FRANKSTON CITY COUNCIL

COUNCIL MEETING SUPPORTING INFORMATION

ADOPTION OF THE FRANKSTON METROPOLITAN ACTIVITY CENTRE STRUCTURE PLAN (JUNE 2023) AND AUTHORISATION REQUEST FOR PLANNING SCHEME AMENDMENT C160FRAN

Attachment A: Draft Frankston Metropolitan Activity Centre Structure Plan Summary of Submissions

Figure 1: Subject site within Precinct 1C of the draft FMAC SP (September 2022)

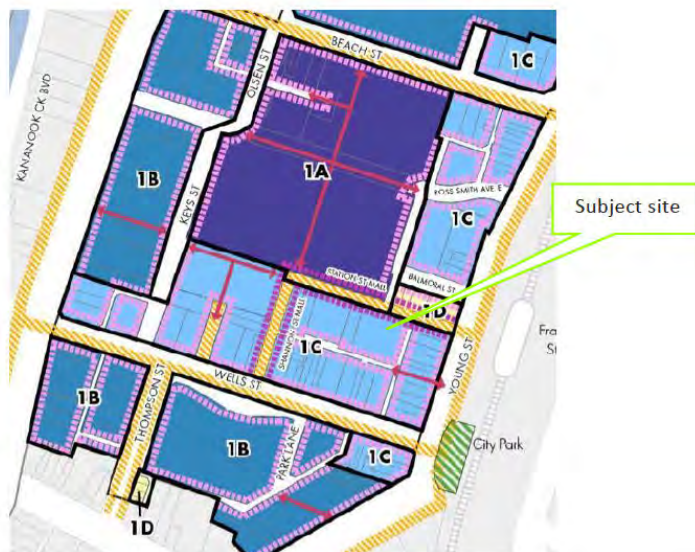
The draft FMAC SP retains the Precinct 1 – City Centre designation as it applies to the subject site. It divides Precinct 1 into three sub-precincts, with the subject site located in Precinct 1C. A preferred maximum building height of 35 metres (10 storeys) is nominated for this sub-precinct (see Figure 2 below). Precinct 1A, located immediately opposite the subject site on the north side of Station Street has a preferred maximum building height of 54 metres (16 storeys).

Principles	Response for subject site
Principle 1	
Design Excellence	It is acknowledged that any proposed redevelopment of the subject site must ensure a standard of architecture and environmentally sustainable design that would contribute to excellent built form outcomes for the FMAC. This principle in itself is not considered determinative of recommendations around building height.
Principle 2	
Strengthen the connection to the Water	With reference to Figure 1 we note that taller building heights are nominated along the western edge of the centre, between the subject site and the water. In this regard the recommended building heights serve to dilute the capacity for a development on the subject site (or its neighbouring sites within sub-precinct 1C) to achieve the principle of strengthen connection to the water. Nomination of a taller building height would better support achievement of this design principle.

Figure 4: Suggested parameters for a new height sub-precinct

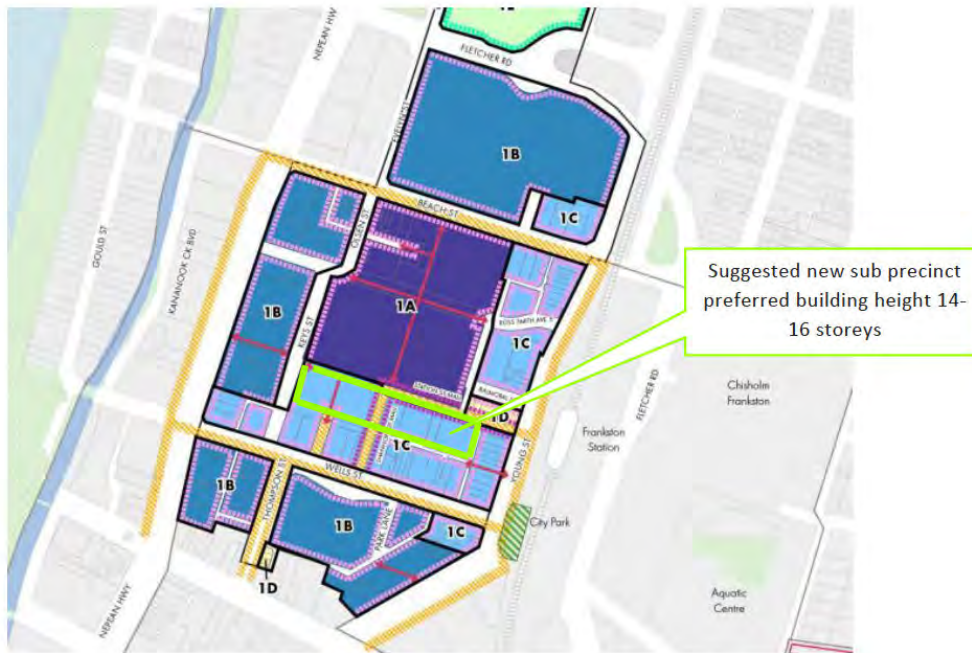
For the reasons outlined, it is considered that the properties along the south side of Station Street, as shown in Figure 4 below, lend themselves to being included in a different height sub-precinct. They could either be absorbed into sub-precinct 1A (16 storeys), or a new sub-precinct 1D could be created with a preferred height of 14 storeys.

Figure 1 – Aerial Image of Site (Landchecker, 18 December 2022)

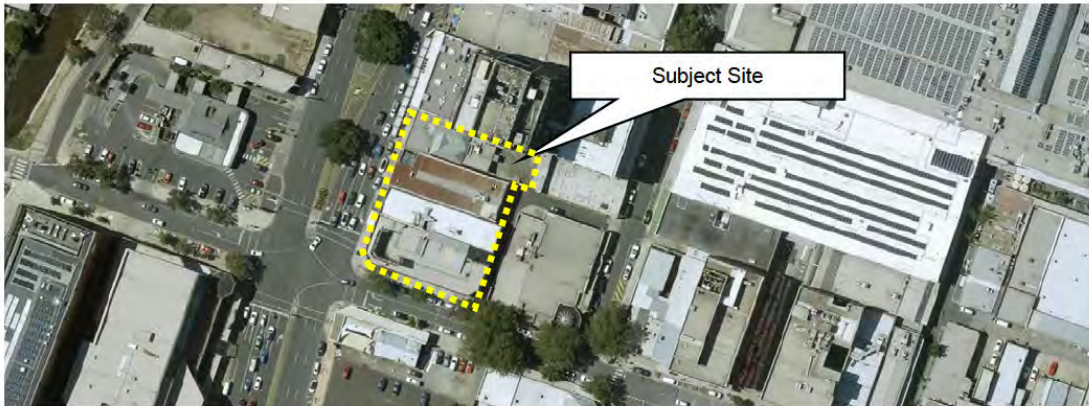
Our clients' combined landholding at 439-447 Nepean Highway (refer to Figure 1) is located within Precinct 1 (City Centre) of the *Draft Frankston Metropolitan Activity Centre Structure Plan October 2022* ("DSP"). Specifically, the land at 439 Nepean Highway is located within Precinct 1B of the DSP, and the land at 441-447 Nepean Highway is located within Precinct 1C, as displayed on the below Precinct Map at Figure 2.

Figure 2 – Precinct 1 Map of the Draft Frankston Metropolitan Activity Centre

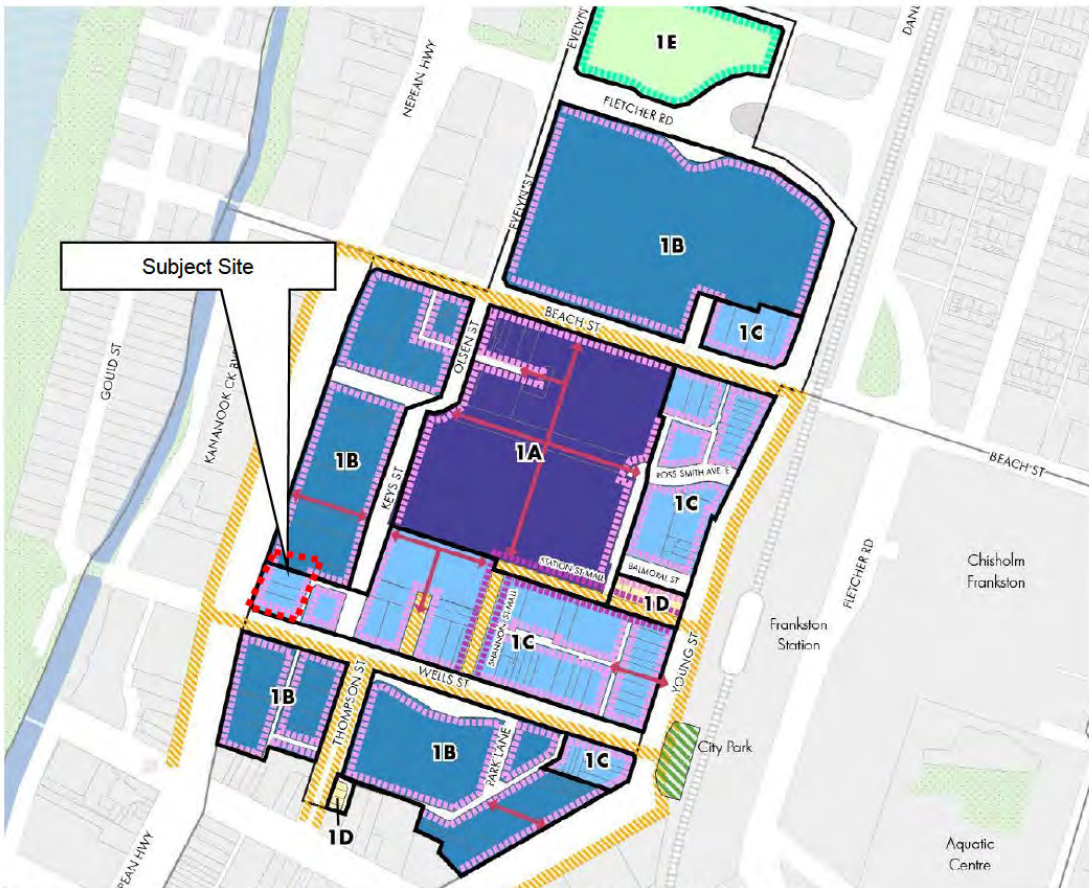
As displayed in the Precinct Map at Figure 2, the combined landholding acts as a bridge between the Precinct 1B land to the north and south of the site as one tracks along the eastern interface of the Nepean Highway. The Precinct 1C land occupies a very small proportion of the Nepean Highway frontage, with all other land along the Nepean Highway being located within Precinct 1B.
